Subject: A S J 訪問

Start: 2015/10/29 (木) 11:00

ASJ: Ms. Sun, Mr. Izam, Mr. Thian, Mr. Penny, Mr. Jovi
Maruwa: Rosli, Mr. Siva, Mr. Ogawa

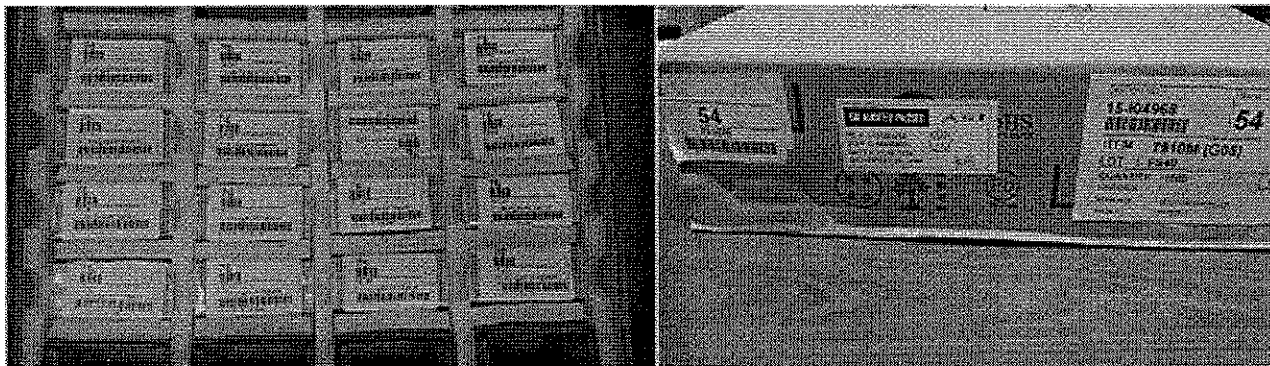
■0402 chip edge break

After chip breaking process, Mr. Jovi found only Maruwa having problem edge break. No similar problem from Sangkang product. This is serious

Issue which might related to market claim from ASJ end customer. Today shown from Lot PO-09.
